IMPORTANT SAFETY RECALL

NHTSA Safety Recall: 22E-055

AWNING INSPECTION AND WELD/SEAM REPAIR

Recall Number:	22E-055		
Product:	Awnings		
Date:	Original: July 15, 2022	Labor Rate:	.30 hours inspection only .30 hours repair only
	Current: Sept. 1, 2022		1.5 hours fabric replacement only

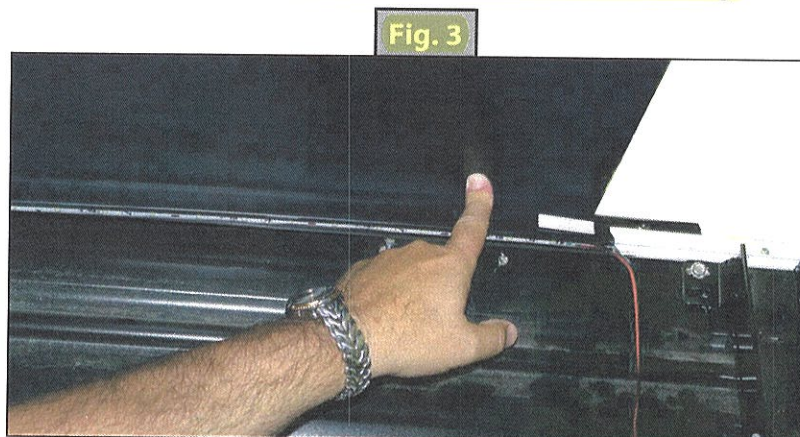
1. Extend the awning.
2. From underneath the awning, about 1" to 1.5" from the fabric edge, push up on the fabric with one finger (Fig. 3) until the awning fabric is flush with the top of the awning rail. Look for any separation or visible daylight at the seam. Perform push test at both ends of the awning.

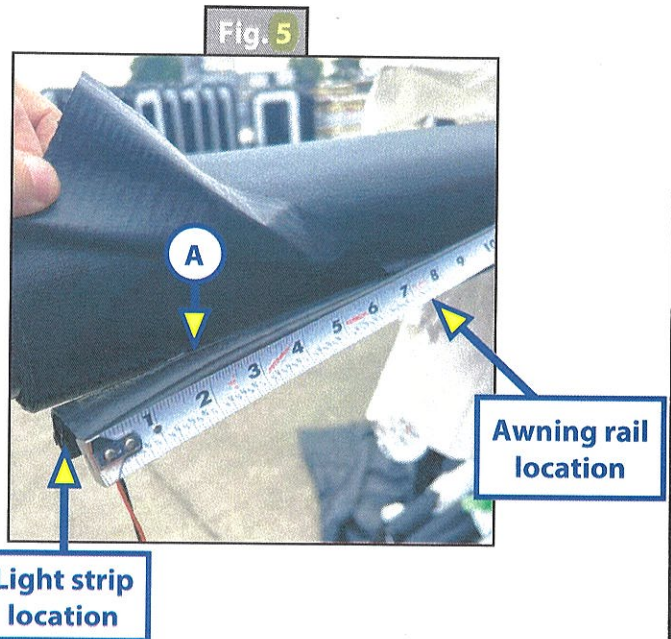
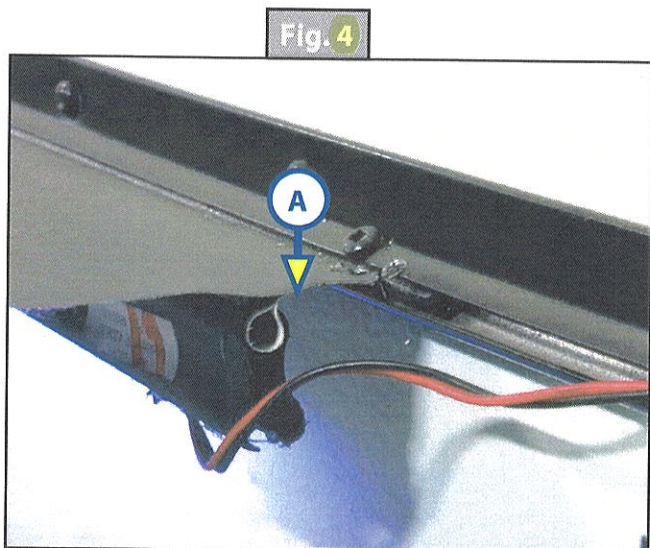
1. Position stepladder next to the unit to view the topside of the awning at the unit wall from either end (drive/idler side).
2. Inspect the weld near the awning rail (Fig. 4A).
 - A. Fig. 4 shows no separation at the seam. It does not require repair or replacement.
 - B. Fig. 5 shows separation at the seam (Fig. 5A).
 - I. If the separation is less than 6 inches, repair can be accomplished using the procedure described in [TI-434](#).
 - II. If the separation is over 6 inches it will require awning fabric replacement using the procedure described in [TI-166](#).
